**MODIFICATION REQUEST:**

**Concept Approval and Stage 1 Project  
Approval at 110 – 114 Herring Road,  
Macquarie Park**

**MP10\_0112 MOD 4 and MP 10\_0113 MOD 4**

Secretary's Environmental Assessment Report  
Section 75W of the  
*Environmental Planning and Assessment Act 1979*

**Figure 5:** Extract of Sydney Building approved ground floor layout (above) and proposed ground floor layout (below).

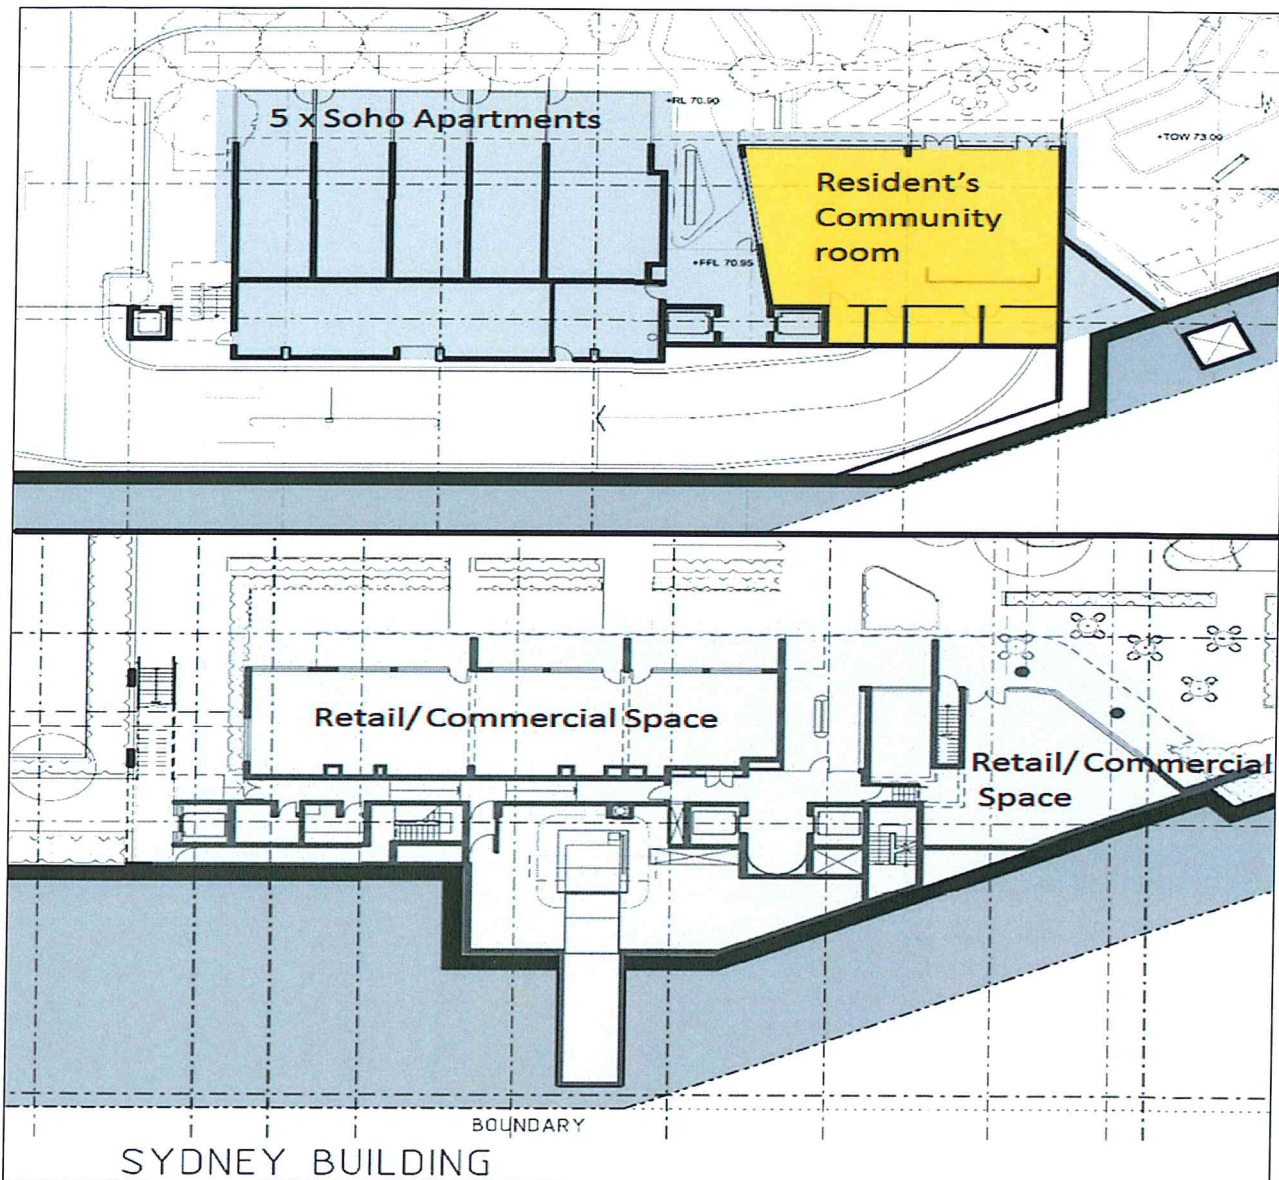
The proposal seeks to amend the ground floor plate of the Sydney Building within Stage 2 to provide 121m<sup>2</sup> of additional retail/commercial floor area (**Figure 5**). This involves:

The Proponent contends that additional commercial/retail floor space will further activate this part of the site and provide for an improved mix of uses within the development.

The Department notes that the additional retail/commercial floor space fronts the Village Green communal open space. The active retail/commercial uses at the ground floor of the Sydney building will assist in activating this part of the site through regular patron activity and also provide convenient retail for residents. Further, the Department is satisfied that the additional retail/commercial floor space is a marginal increase and will not be detrimental to the mix of uses on site and will maintain the predominantly residential nature of the site. The minor change in the ground floor building envelope is generally consistent with the existing approval.

**Figure 6:** Extract of Sydney Building ground floor showing residents' community room and 'Village Green' communal open space.

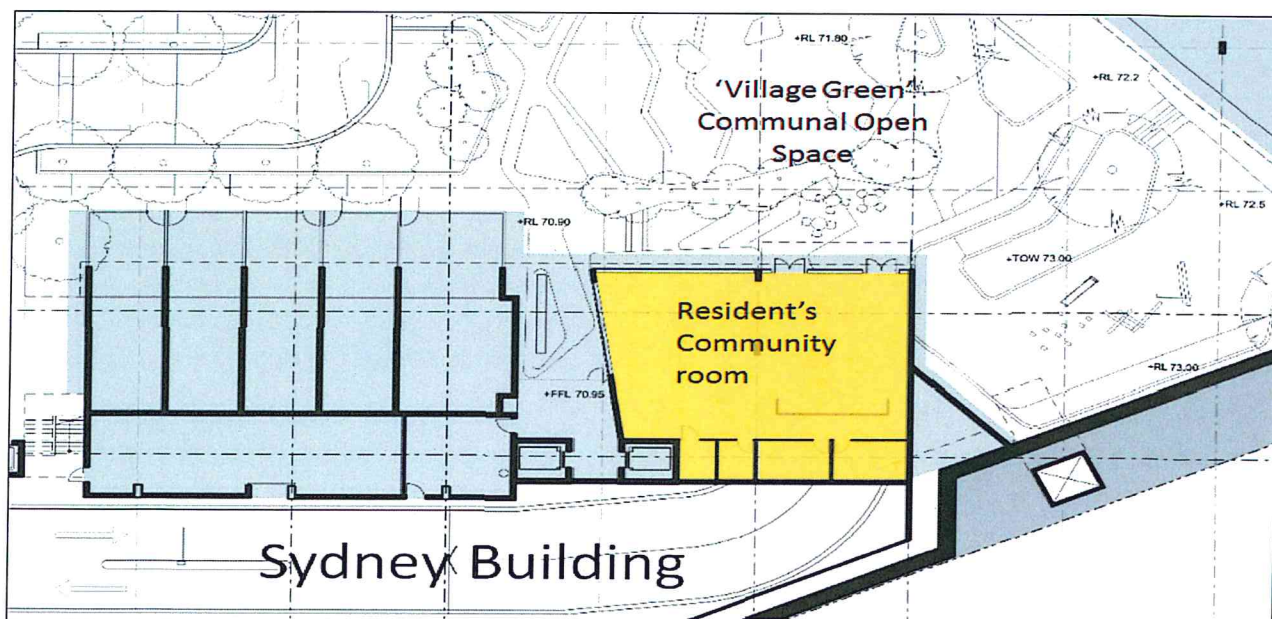
The Concept Approval provides a 200m<sup>2</sup> residents' community room within the ground floor of the Sydney Building within Stage 2 which was indicatively shown to include a kitchen, store area, toilet, and a minimum four metre floor to ceiling height. The room fronts the Village Green communal open space which can be used as an informal spill out area for the residents' community room (**Figure 6**).

**Figure 7:** Extract of Perth Building and Brisbane Building ground floor showing proposed residents' community room in yellow and associated outdoor space (orange hatchet)

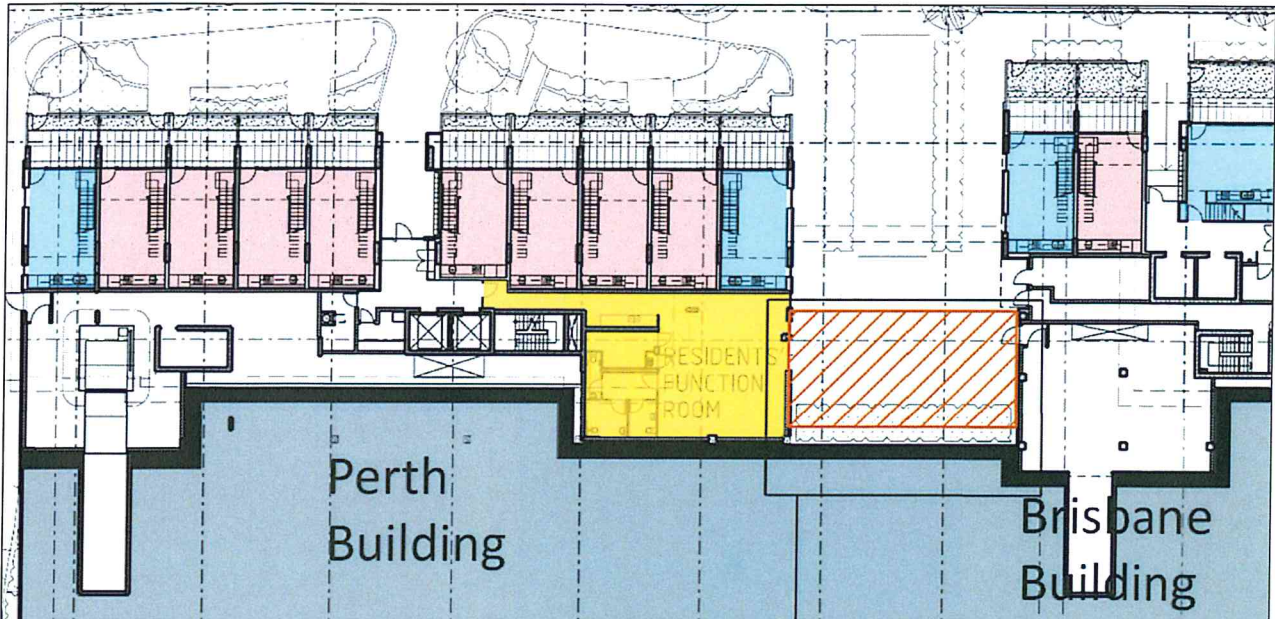
The proposal seeks to relocate the approved residents' community room from the Sydney Building (Stage 2) to the ground floor of the Perth Building (Stage 1) (**Figure 7**). The relocated residents' community room has a gross floor area of 125m<sup>2</sup> comprising kitchen, store area, toilets, minimum floor to ceiling height of 5.5m, and extends onto a dedicated 100m<sup>2</sup> outdoor area. This outdoor area provides a formal extension of the community room and is fully covered by an operable rain screen.

The total internal and external area of the relocated residents' community room exceeds the indicative area of the previously approved community room and is fully usable in all weather conditions. The Department is satisfied that the relocated residents' community room is acceptable and will provide a comparable space to that currently approved for the following reasons:

- despite the relocated residents' community room being smaller in internal size by 75m<sup>2</sup>, an additional 100m<sup>2</sup> of dedicated outdoor space is provided directly adjacent to this room, increasing the total area to 225m<sup>2</sup> (**Figure 8**);

- the residents' community room will be delivered as part of Stage 1, which is an earlier stage of the development than previously proposed;
- the proposed new communal open space between the Perth Building and Brisbane Building will provide a similar amenity for the residents' community room as per for the previous location;

- the new residents' community room will have a greater floor to ceiling height of minimum 5.5m (compared to the approved 4m), providing greater amenity for future users; and

- as discussed in **Section 5.2**, relocating the residents' community room to the Perth building will provide for a better outcome to the space at the Sydney building as a retail/commercial space will better activate the Village Green through regular patron activity a when compared to the intermittently used residents' community room.

**Figure 10:** Northern elevation showing proposed (above) and approved (below) facades of Darwin and Darwin buildings

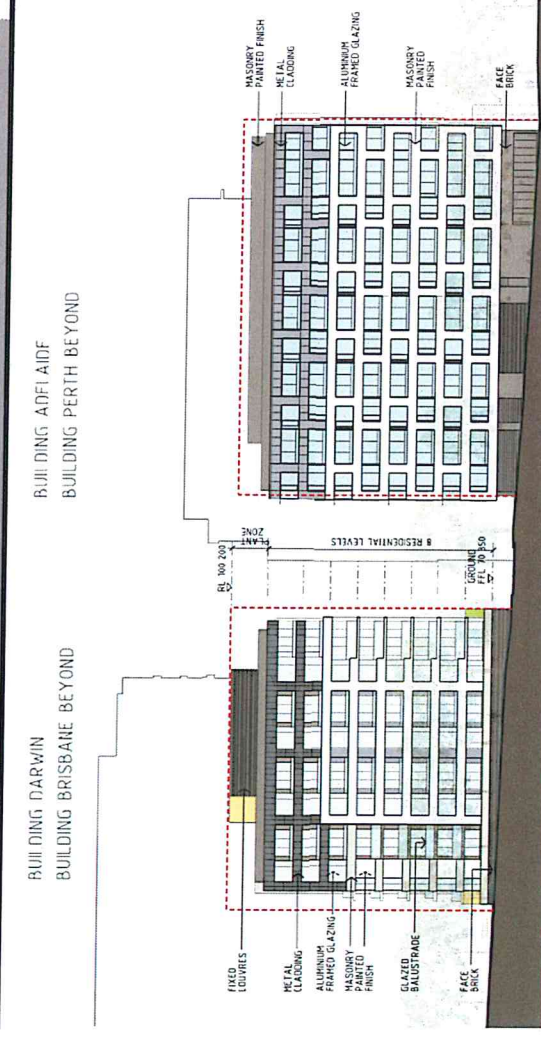
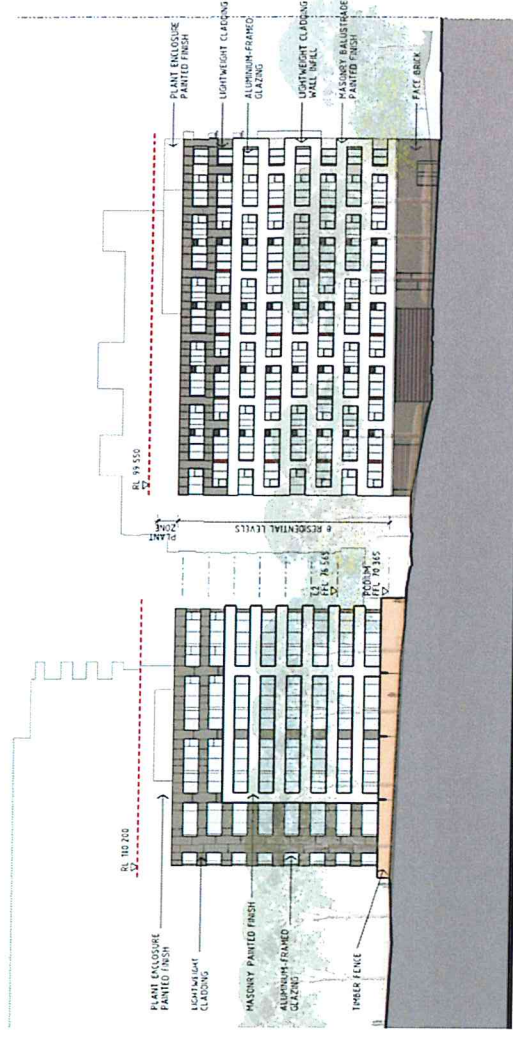
A comparison of the approved and proposed building facades in Stage 1 is shown in **Figures 9 and 10**.

The Department has examined the proposed changes to the external facades and is satisfied the changes to materials and finishes, window placement, shading, awnings and screening remains of a high quality and provides the same level of variation, articulation and visual interest as the approved design.

The external changes do not adversely affect the visual bulk and appearance of the buildings and the minor reductions in height are consistent with the maximum approved building envelopes under the Concept Approval. Overall, the Department concludes that the proposed external design changes are acceptable and maintain a high standard of architectural design consistent with the approved development.

**Figure 11:** Approved (above) and proposed (below) Landscape Masterplan

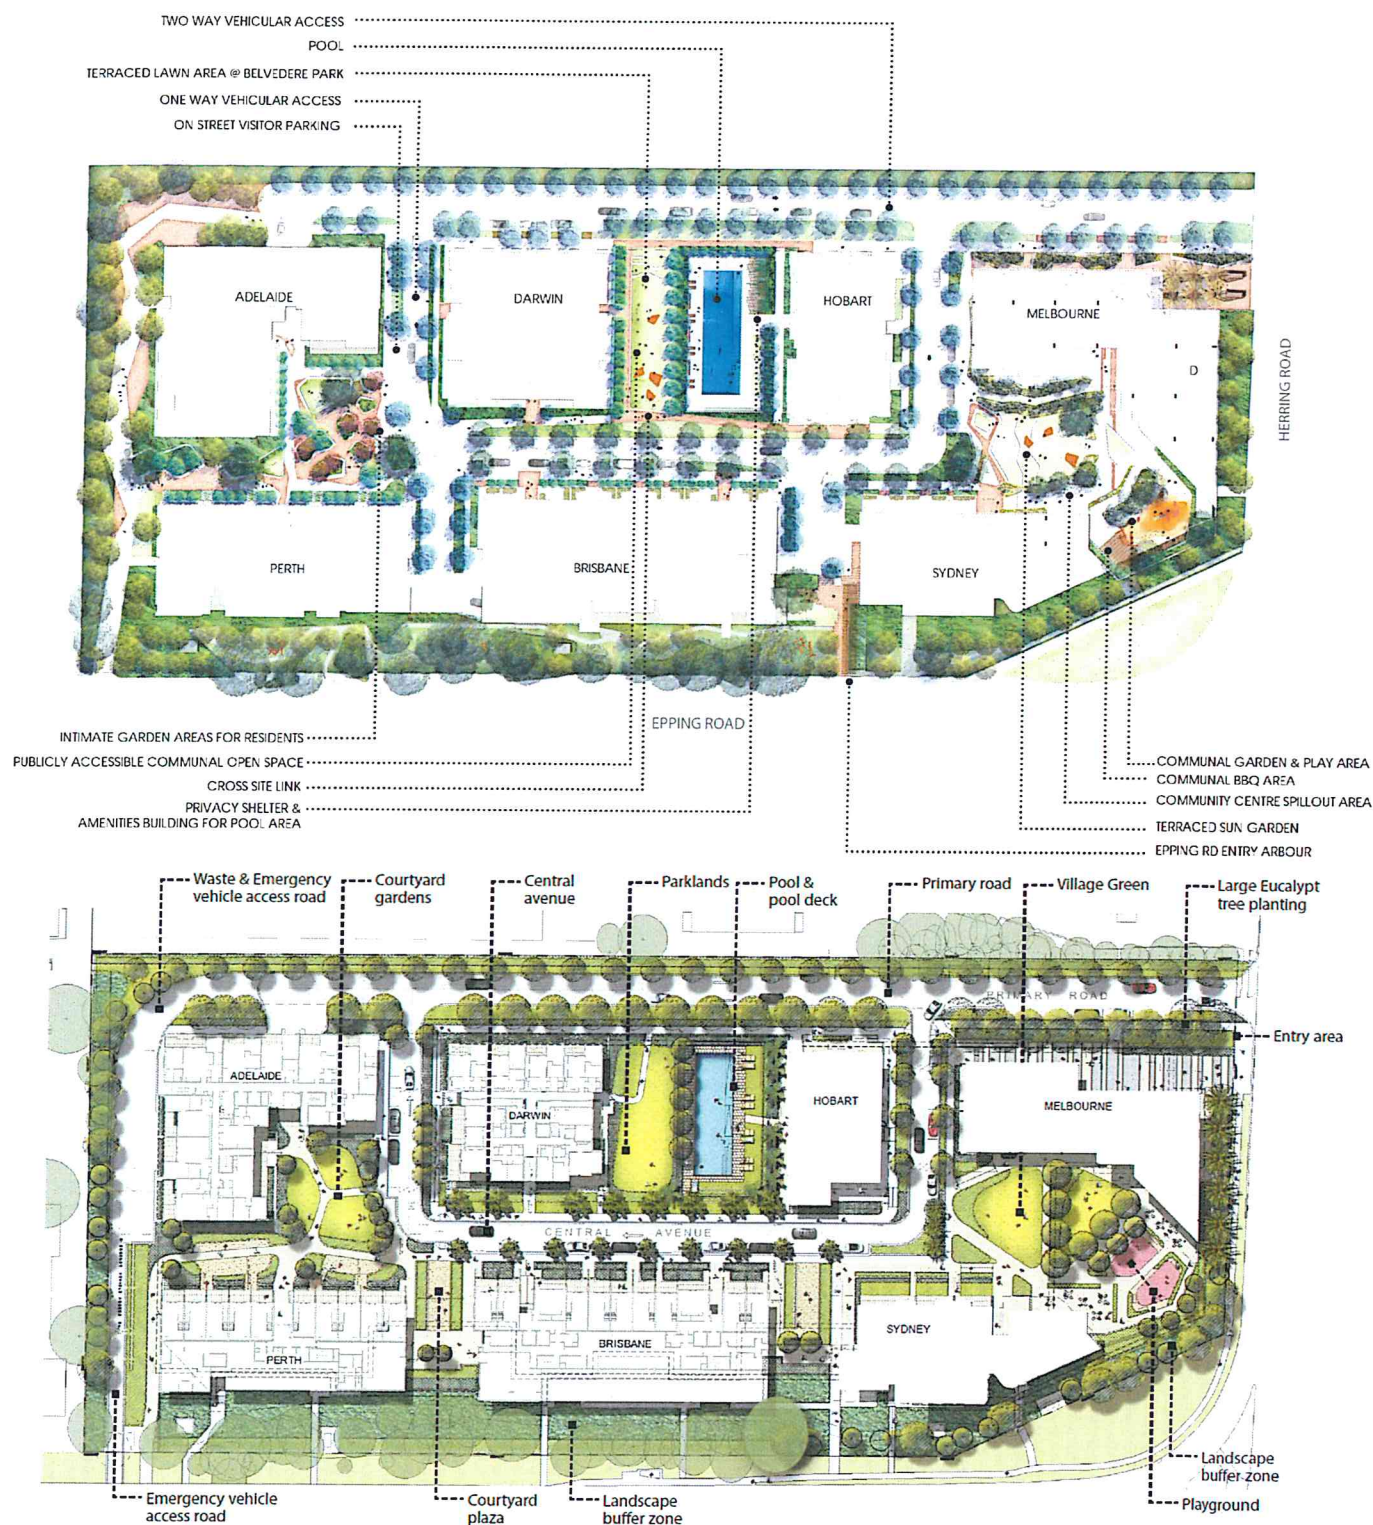
A comparison of the approved and proposed public domain concept plan is provided at **Figure 11**.

The Department has considered the revised landscape masterplan and considers that:

- the provision of an additional in two communal open spaces between the Perth, Sydney and Brisbane buildings results in an improved amenity outcome for future residents compared to the previous roadways;
- the design changes in terms of planting and pathways are generally minor and retain the general landscape character approved for the development
- the relocation of the amenities facilities servicing the swimming pool will continue to provide appropriate facilities for future users;
- the provision of a BBQ area adjacent the swimming pool is supported, however the Department also considers that BBQ facilities should retained in the Village Green as the principle open space for the development. The Department therefore recommends a condition requiring BBQ facilities in the Village Green.

- deletion of the internal access road between the Perth building and Brisbane building as it is no longer required with the relocation of the loading dock and waste storage/collection area to the basement;
- deletion of the basement entry at the Sydney building and the associated internal access road between the Brisbane building and Sydney building; and
- reintroduction of a road along the northern boundary to provide vehicular access to the basement waste storage/collection area and emergency vehicle access from Epping Road (**Figure 11**).

The Department initially raised concerns that the deletion of the basement entry would leave only one remaining single entry and exit point into the basement car park. In response, the Proponent confirmed that two entry lanes and one exit lane will comfortably cater for the likely traffic movements of approximately 149 vehicles per hour during peak for the development.

After consideration of the additional information, the Department is satisfied that the consolidation of vehicle access to the basement via a single entry can operate satisfactorily without adverse impacts on the efficiency of the car park entry and exits. Further, the deletion of the second basement access will allow for an additional communal open space for residents between the Brisbane and Sydney buildings which will provide increased residential amenity.
